Livermore Area Recreation and Park District

Board Meeting Update Public Comments Summary

WILLIAM PAYNE SPORTS PARK RENOVATION PROJECT

Re: Comments - William J. Payne Sports Park Renovation Project IS/MND

*Zone 7 pipeline
shown in blue*

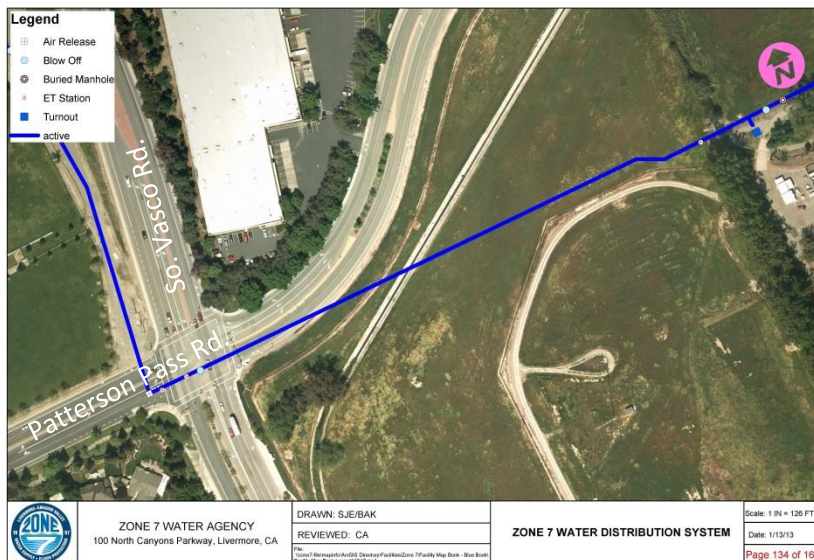
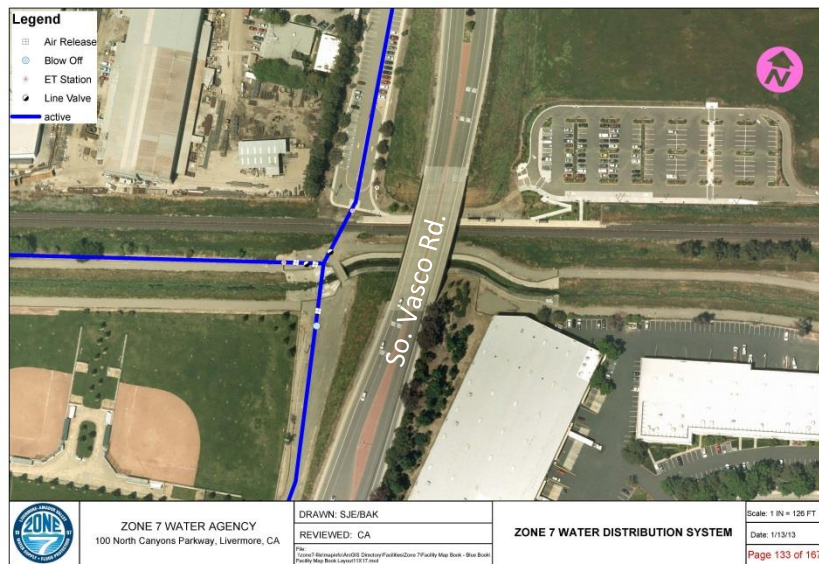
1. **Access to Line P-1.** Zone 7 must maintain access to both the flood control channel (Line P-1) and the adjacent maintenance road, which run along the north border of the project site. Our typical access to the channel is via S. Vasco Rd.
2. **Existing Facilities – Pipeline.** Be advised that our *Livermore Pipeline* runs along the north and east sides of the project area. Specifically, the pipeline runs across the channel (Line P-1) along the north side of the site, then runs south along the east side of the park in a gravel area between the fields and S. Vasco Rd. See blue line in three images below.

William J. Payne Sports Park Renovation Well Table

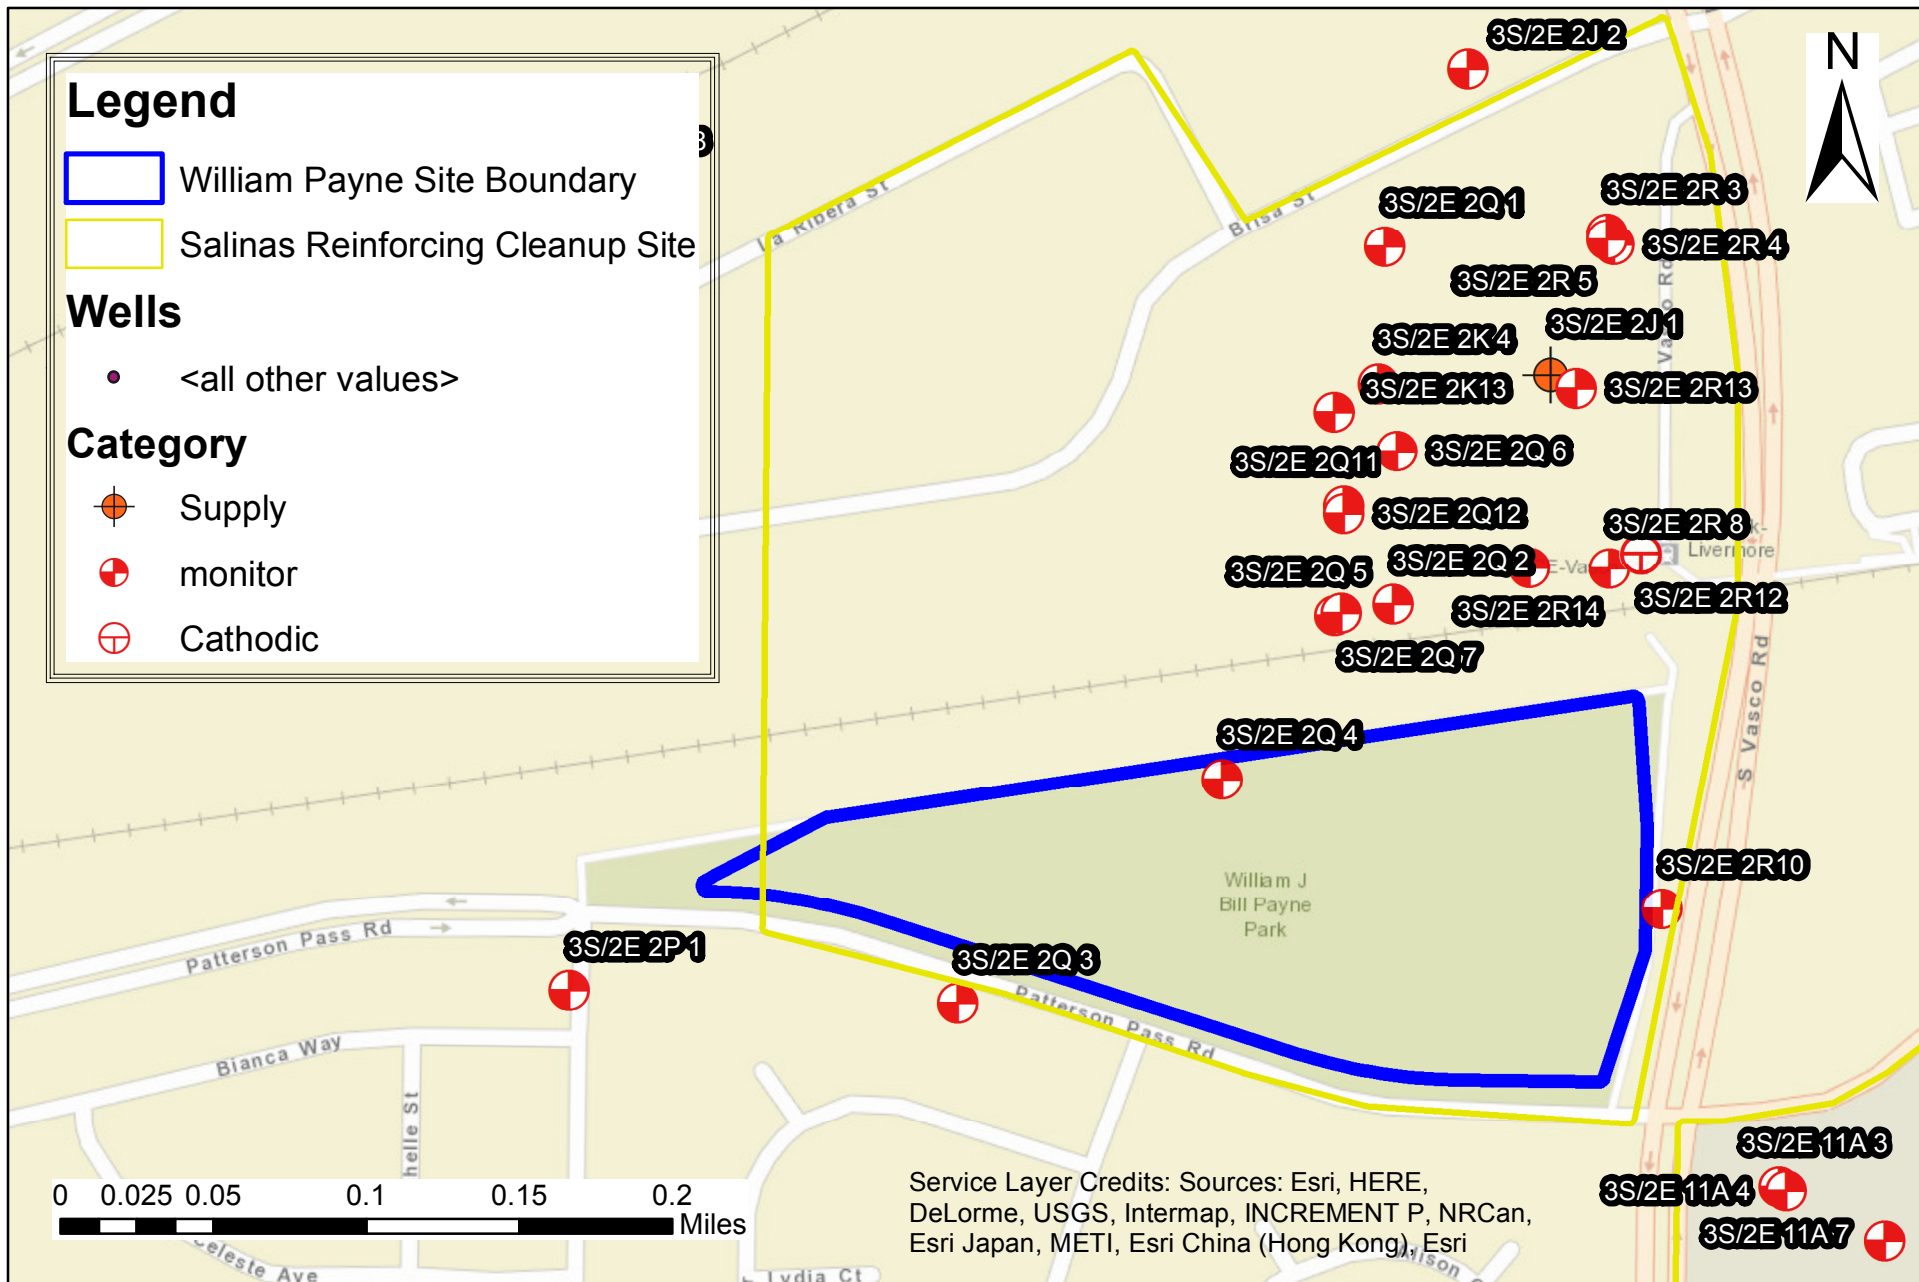
3. **Existing Facilities - Wells.** Our records indicate that there are two water monitoring wells (3S2E02Q04 and 3S2E02R10) in the project area. The approximate locations are shown on the enclosed Well Location map. Please immediately notify Zone 7 if any other wells exist in the project area. All well locations should be field verified and noted on the plans. A Zone 7 drilling permit is needed for any water well or soil boring work that may be planned for this project. Also, the project area is located in the *Salinas Reinforcing Cleanup Site* and therefore subject to Zone 7 Special Drilling Requirements. Well permit applications and the permit fee schedule can be downloaded from our website: www.zone7water.com, or requested by email sent to wellpermits@zone7water.com. Additional information can be obtained by contacting Michelle Parent at (925) 454-5077.
